Central Sewershed Package 7-Brackenridge High School
Solicitation Number: CO-00423
Job No.: 18-4543

ADDENDUM 02

May 28, 2021

SEWER BLOCK MAP

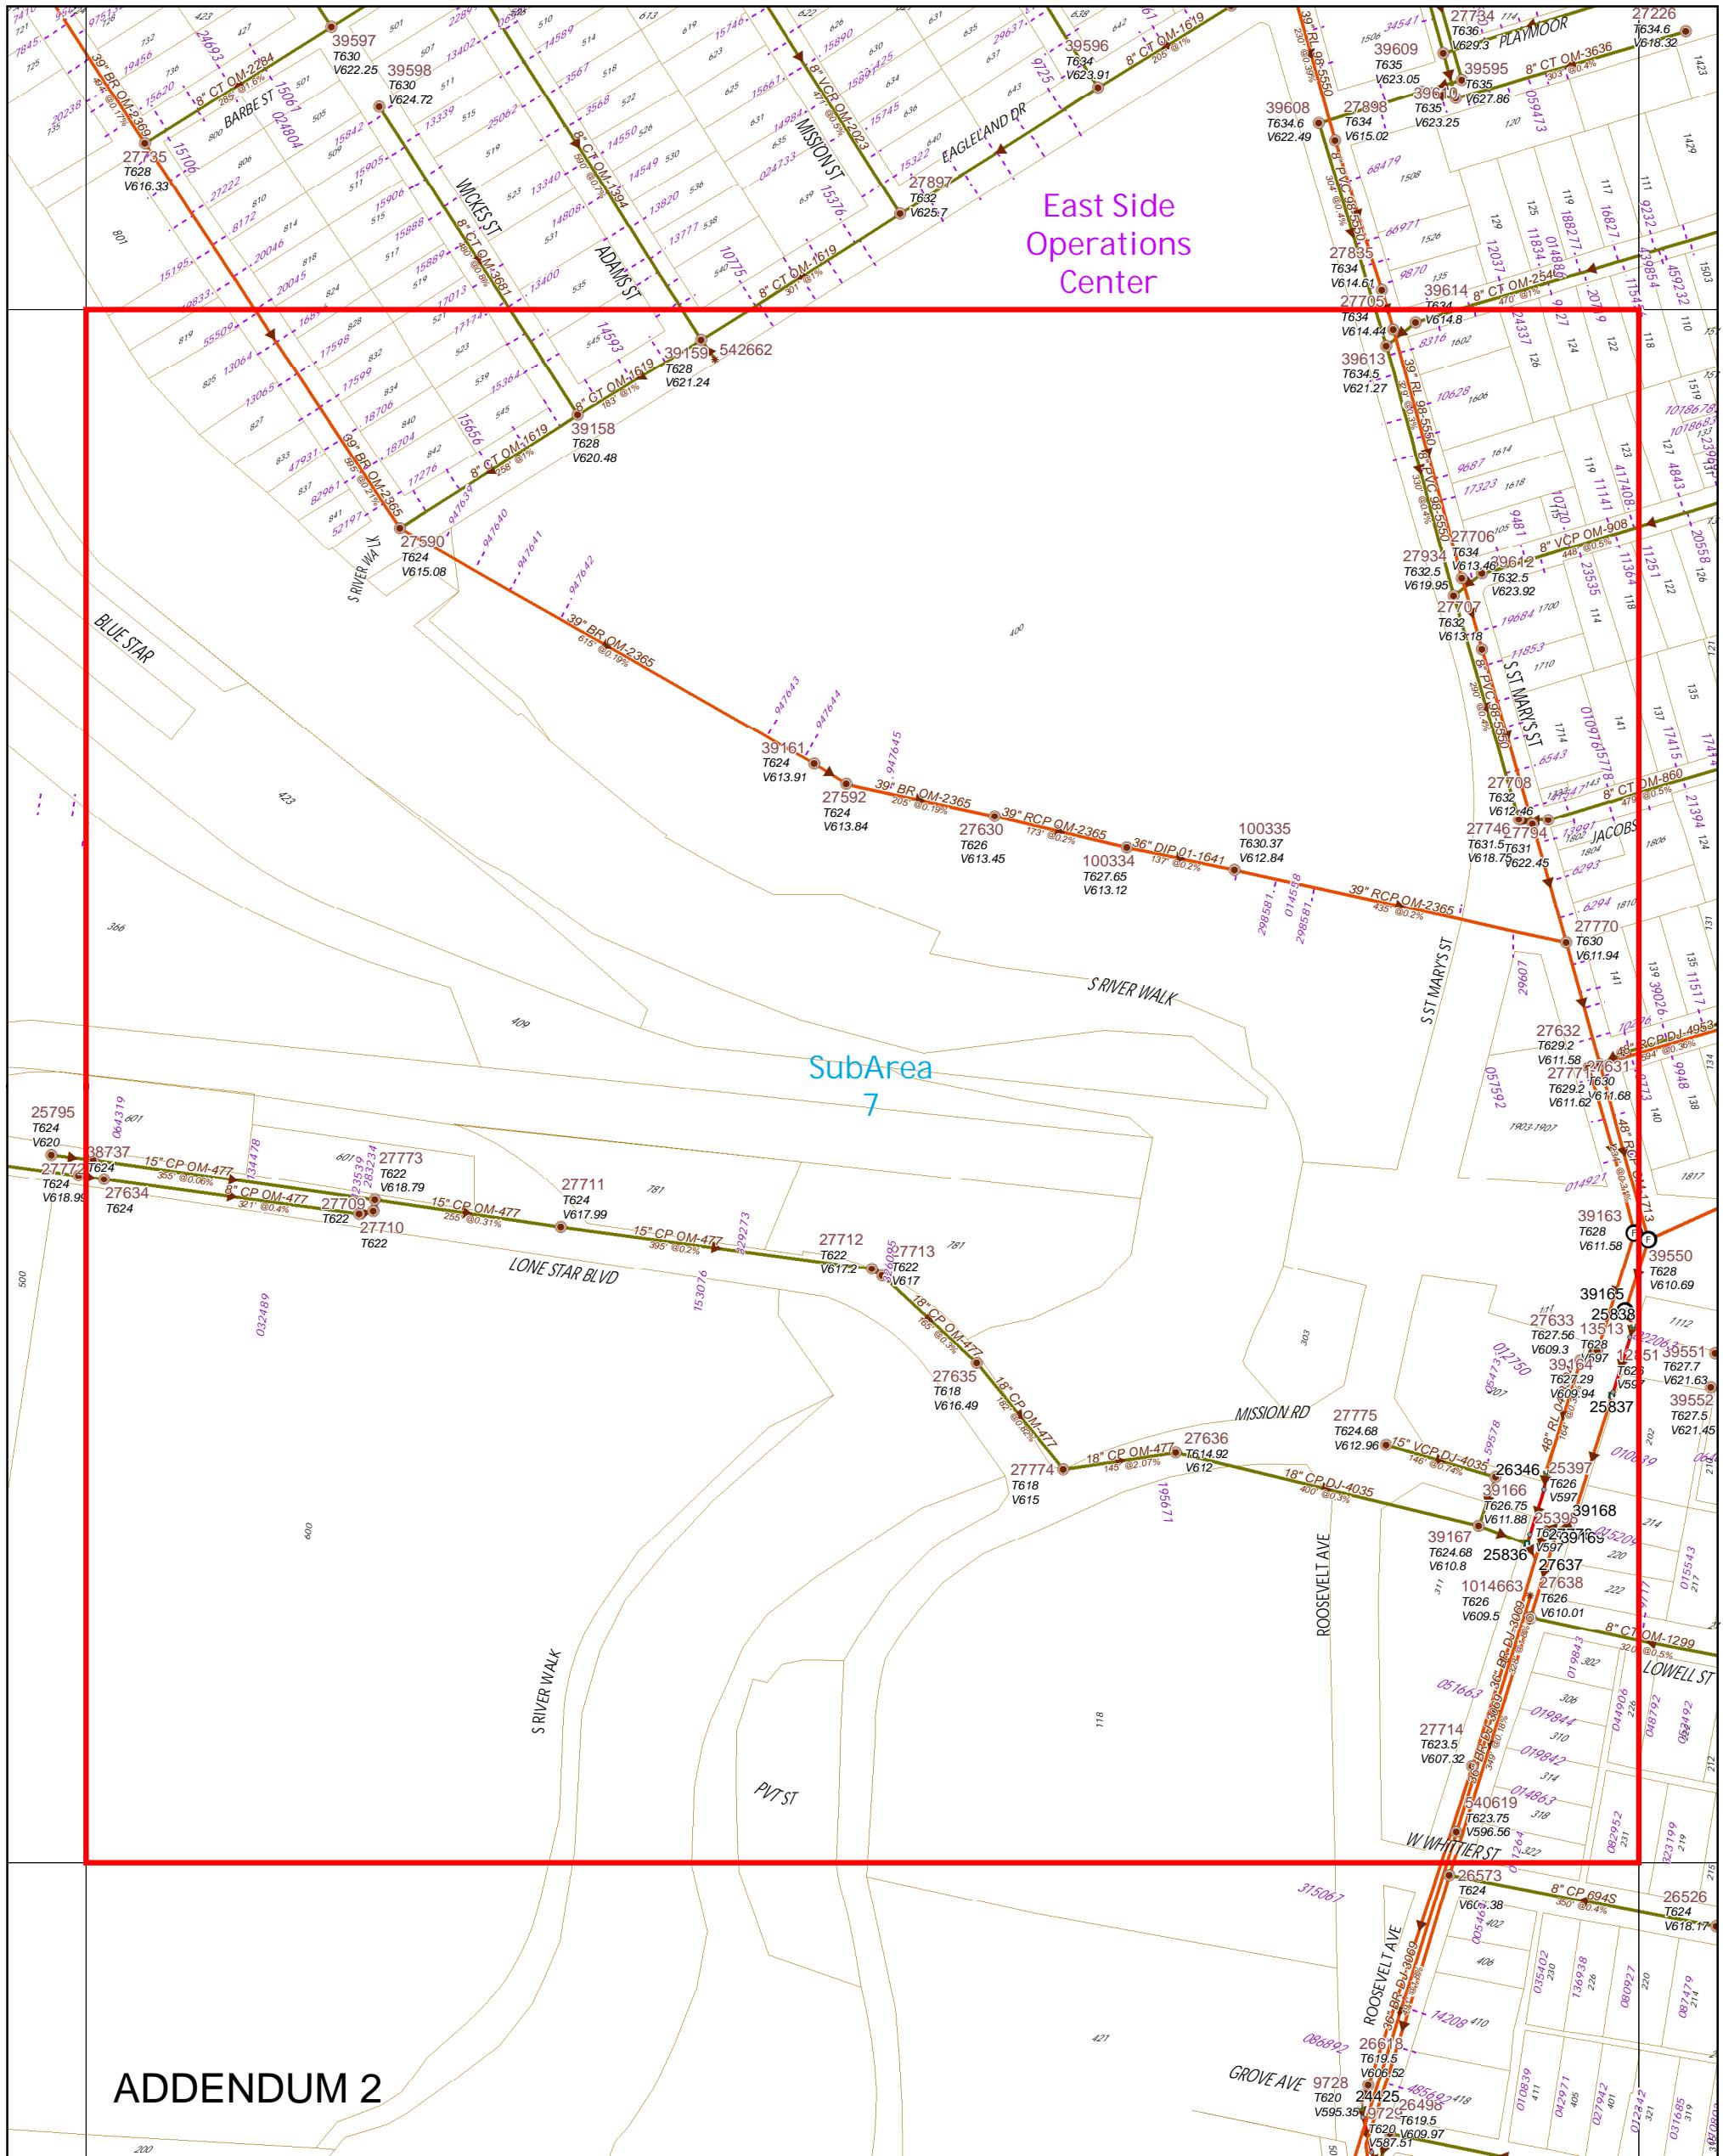
25. Are there profile plans available for the 39" Sanitary Sewer main that is to be lined with CIPP on this project? The over head plan is included in the plan set but I was unable to locate a profile.

Answer: As-built record drawings for the existing 39-in sanitary sewer are not available, but Sewer Block Map 162570 is provided as Attachment 7 to show manhole rim and invert elevations on the existing 39-in sewer line.
